ERRATA

Simplified Design – Reinforced Concrete Buildings of Moderate Size and Height –Third Edition (Publication EB104)

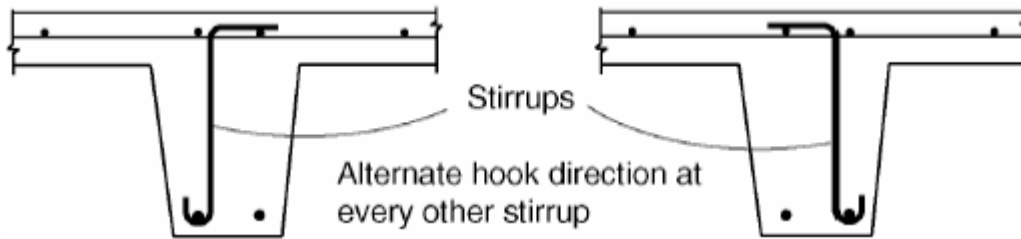
12. Page 3-31, 8th line, change “53” to “66 in.”
13. Page 3-35, 4th and 5th lines line below Figure 3-15 caption, delete the words “a continuous.....configuration”.
14. Page 3-35, Replace Figure 3-16 with the following figure:
